## EXHIBIT LIST

# Chilterns Tunnel - mitigation options for the River Misbourne

### Wendover Green Tunnel and North Cutting Hydrogeological Impact Assessment - Technical Note

Document Number: C252-ETM-EV-NOT-020-000161

Figure 1: Map of the Wendover area.

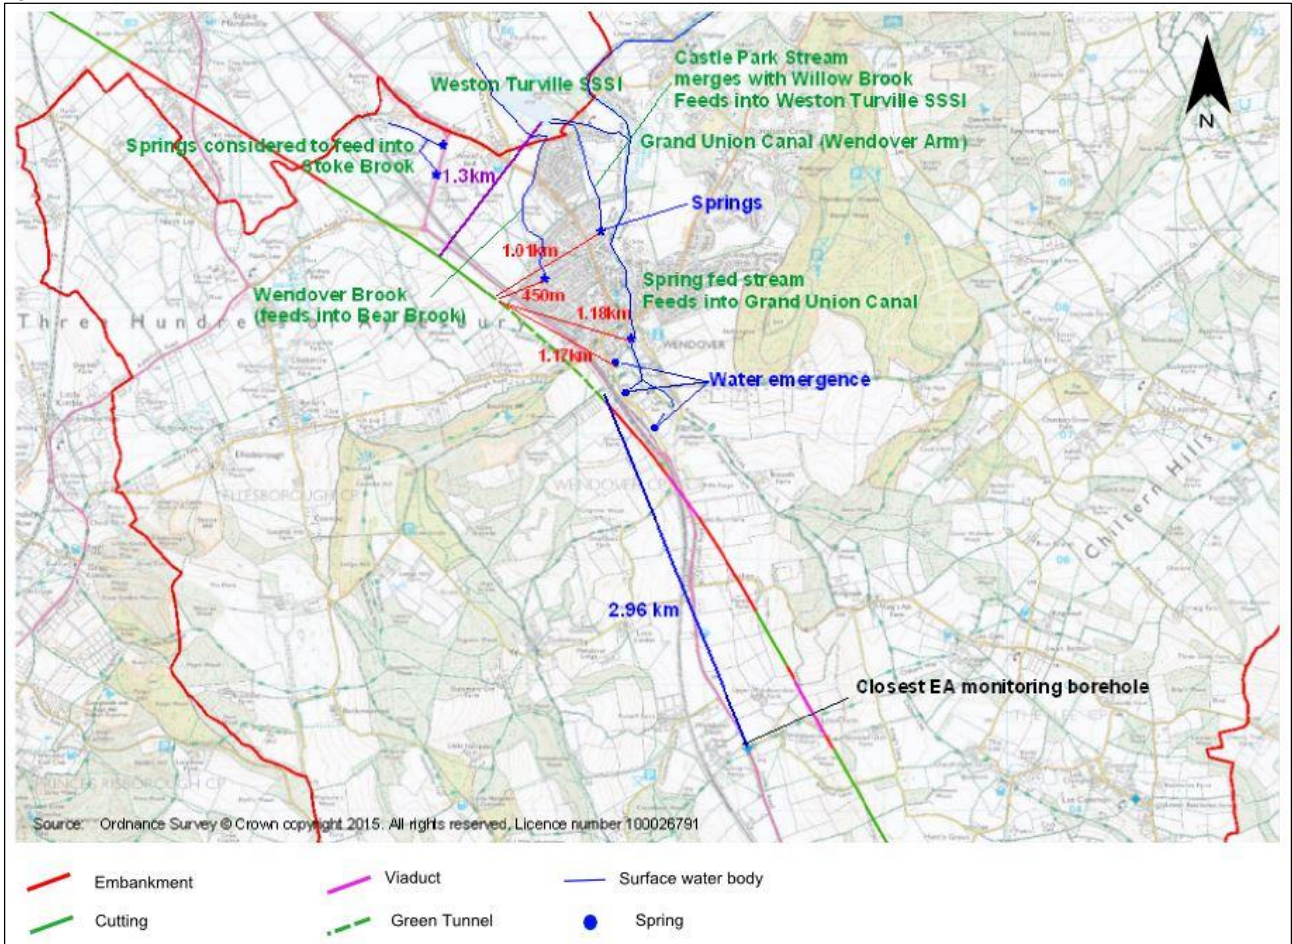
- 4.1.8 Figure 1 (Section 6) shows the proximity of the Wendover green tunnel and north cutting relative to the springs, streams and the nearest Environment Agency monitoring borehole.

Figure 2: Construction boundary and LLAU boundary with potential drainage options.

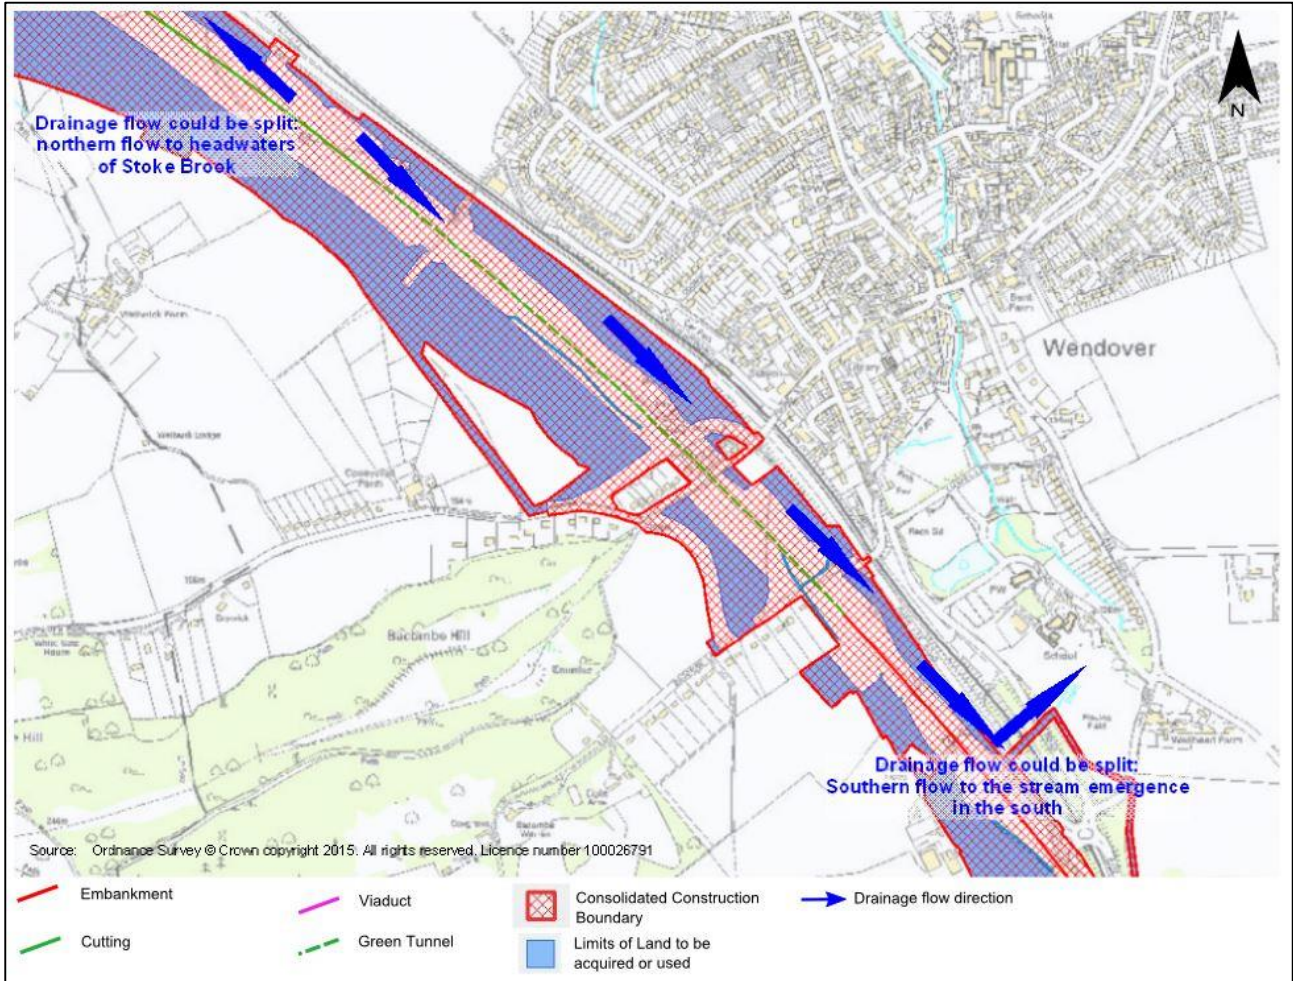
A portion of the abstracted groundwater, for the purposes of dewatering the cutting, could be pumped up-gradient, through the cutting, to a discharge point close to where the streams emerge, as indicated in

- 4.2.2 Figure 2 (Section 6). This would require pumping, and so would be undesirable due to sustainability reasons, but may only be required at certain times of year.
- 4.2.3 However, by implementing this type of solution (i.e. discharge of abstracted water in targeted areas, where we have the powers to do so) it is considered feasible to mitigate impacts on water resources receptors if the impact predicted from the ground investigations and monitoring is greater than assessed in the ES.
